DART AEROSPACE LTD	Work Order:	38971
Description: Plate	Part Number:	D3303-1
Inspection Dwg: D3303 Rev: B		Page 1 of 1

# **D3303-041 HEAD REST**

Subject: RE: D3303-1 hole for MS20470AD4 rivet

DESIGN	DRAWNBY	DART AEROS	
CHECKED PH	APPROVED	DRAWING NO. D3303	REV. B SHEET 4 OF 4
DATE 06.08.17		TITLE HEAD REST	SCALE 1:2

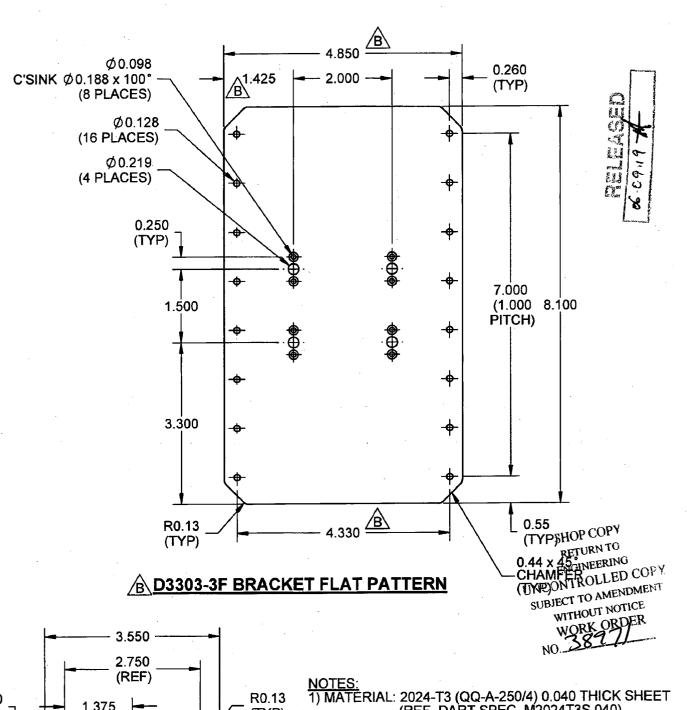
NCR: 考	8971	W	ORK OR	DER NON-CONFORMANO	CE (NCR)			
		Description of NC		Corrective Action Section B		Verification	Annroval	Ammroyal
DATE	STEP	Section A	Initial Chief Eng	Action Description Chief Eng	Sign & Date	Section C	Approval Chief Eng	Approval QC Inspector
08.05.03	2	QTY(3) have enlarged holes upto operated of 0.140. Consecutive holes in row. Root Cause: Wateriset machine requires maintance	Q55 042 08.05.07		\$53	००१०५१०८	04.05.07	08/05/0
	·			0				
		•

Production is making a D3303-1 plate on the waterjet. Some of the 0.128" holes for the MS20470AD4 rivet have been elongated to 0.138" in diameter (see attached). This part is for the D3303-041 Head Rest. The 0.138" hole is outside the tolerance of 0.128" holes.

Is this deviation acceptable?

FYI – Eric Downing has indicated to me that waterjet is in need of maintenance (parts on order) and that is why we are getting some of the holes for flat patterns elongated. This sort of deviation is a temporary problem.

From our discussion, it sounds like its only 4 out of 16 holes that are oversized and that they are randomly scattered about the part.

If this is the case, then these parts are acceptable.

If it had been every hole, then I would have been concerned about the parts becoming loose because of aircraft vibration.
